SUBJECT: ISSUANCE OF AMENDMENTS (TAC NOS. M89068, M89069, M89070 AND M89073)

SAFETY EVALUATION BY THE OFFICE OF NUCLEAR REACTOR REGULATION
RELATED TO AMENDMENT NO. 128 TO FACILITY OPERATING LICENSE NO. DPR-19
AMENDMENT NO. 122 TO FACILITY OPERATING LICENSE NO. DPR-25,
AMENDMENT NO. 148 TO FACILITY OPERATING LICENSE NO. DPR-29
AND AMENDMENT NO. 144 TO FACILITY OPERATING LICENSE NO. DPR-30

DRESDEN NUCLEAR POWER STATION, UNITS 2 AND 3

QUAD CITIES NUCLEAR POWER STATION, UNITS 1 AND 2

FIGURE 1

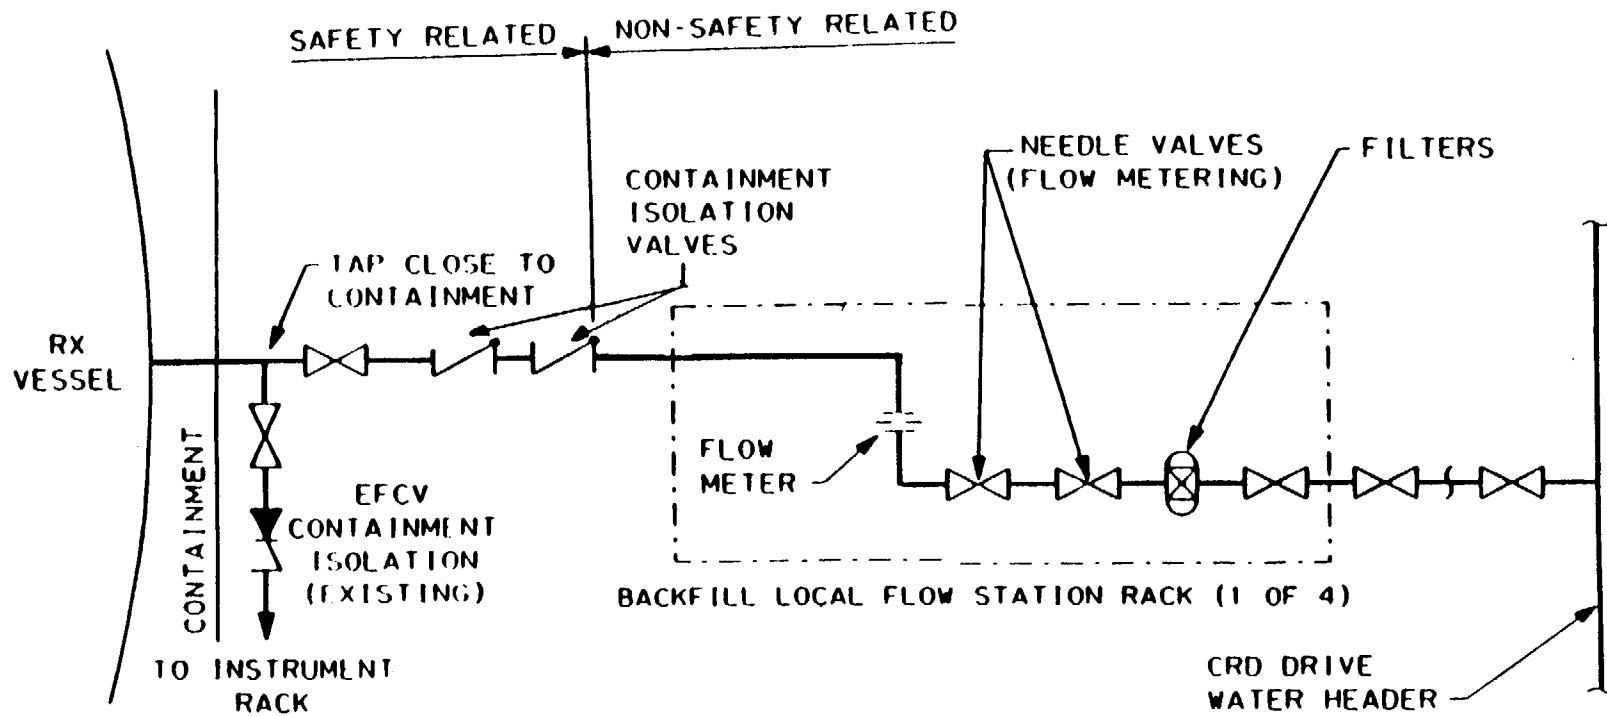
The modifications will connect backfill piping to the RPV reference leg instrument lines. The purpose of the backfill piping is to provide a continuous flow of degassed CRD system water to the RVLIS reference leg piping. This will ensure that a continuous column of water, free of any non-condensable gases, is maintained in the reference leg piping. This modification will eliminate the occurrence of the "notching" effect in the RPV level instrumentation during RPV depressurization due to the presence of dissolved gases. The design of the backfill system injects water from the CRD system to the instrument reference legs between the containment penetration and the existing primary containment isolation valves (excess flow check valves). Figure 1 provides a simplified diagram of the backfill modification.

The connection location of the backfilled reference leg piping physically eliminates the consequences of an inadvertent RVLIS reference leg root valve manipulation error as described in Information Notice (IN) 93-89, "Potential Problems with BWR Level Instrumentation Backfill Modifications."

The backfill lines are connected in such a manner that they do not have an adverse effect on the capability of the connected instruments to perform their intended function. The backfill lines have no effect on the response time and

no significant impact on instrument accuracy. The design of the backfill system does not impact the redundancy, independence and testability requirements of the reactor protection system. The backfill lines are designed to the same level of quality as the existing instrument lines. The new check valves will not close inadvertently during normal operation, but will isolate when the backfill instrument line integrity is challenged during normal or accident conditions. The backfill line check valves will isolate if CRD system pressure falls below reactor pressure and will re-open under conditions that necessitate re-opening because the CRD water pressure is greater than reactor pressure.

One of the effects of the proposed addition of the backfill lines which inject inboard of the root valve is to extend the containment pressure boundary out to the safety-related backfill lines to the containment isolation devices separating the backfill lines from the non-safety-related CRD system. The licensee has proposed installing two check valves, in series, in each of these two subject backfill lines as the containment isolation devices required by GDC 55 of Appendix A to 10 CFR Part 50. GDC 55 prescribes four specific containment isolation valve arrangements for lines penetrating containment, but also allows for alternate containment isolation approaches. Since the licensee's present proposal does not conform with any of the valve arrangements prescribed in GDC 55, the licensee has proposed an alternative compliance as provided for in GDC 55.

The advantage of extending the containment pressure boundary out to the two subject check valves in the four reference legs which provide engineered safety feature (ESF) actuation signals is offset by eliminating the possibility of inadvertently isolating the instrument racks from the reactor pressure vessel by closing the manual root valve, thereby potentially subjecting these instruments to the CRD system pressure of 1300 psi, which could result in a severe transient at the Dresden and Quad Cities Stations.

The new check valves themselves provide greater leak tightness than other valves used on similarly sized lines. They have low opening pressure and a soft seat which will not cause pressure spikes in the downstream instruments. The isolation capability of the backfill line check valves will be periodically verified by testing to leak rate criteria that is significantly more restrictive than the 10 CFR 50, Appendix J, minimum leak rate testing requirements. In addition, inclusion of all the new check valves into TS Section 3.7/4.7.D requires that these valves be subject to Type C testing in accordance with 10 CFR 50, Appendix J.

The new piping connects into the reference instrument line legs on each unit inboard of the existing containment isolation valves. These new lines are part of the reactor coolant pressure boundary. Therefore, the intent of GDC 55 is applicable to these reference leg backfill lines.

GDC 55 requires each line that is part of the reactor coolant pressure boundary and penetrates primary reactor containment be provided with containment isolation valves meeting specific criteria. GDC 55 allows deviation from these specific criteria, if it can be demonstrated that the containment isolation provisions for a specific class of lines are acceptable on some other defined basis.

The licensee's defined basis, as required by GDC 55, for the acceptability of the two subject check valves separating the safety-related portion of the backfill lines from the non-safety-related CRD system is based on the following:

In all cases, the check valves will be located within 15 feet of the containment penetration.

- 4) The same provisions are made for visual inspection of the backfill piping as for the original instrument lines up to and including the containment isolation check valves. These valves are being added to the inservice test (IST) and local leak-rate test (LLRT) programs.

- 5) The backfill line connection made to the reference legs is such that the response time of the connected instrumentation is not affected.
- 6) The backfill lines will not close accidentally during normal reactor operation because CRD drive water flow will keep the check valves open. The CRD drive water flow is checked daily on operator rounds.

proposed modification is insignificant as existing line break analyses bound the consequences of a loss of backfill line integrity. Based on the above, the staff finds the design of the proposed modifications meets the intent of GDC 55 and also meets Bulletin 93-03, and are, therefore, acceptable.

Based on the above evaluation, the staff finds the design of valves is adequate as containment isolation valves. Adding the valves to the TS assures the valves will be operable and are maintained and monitored as primary containment isolation valves. Therefore, the staff finds the proposed change acceptable.
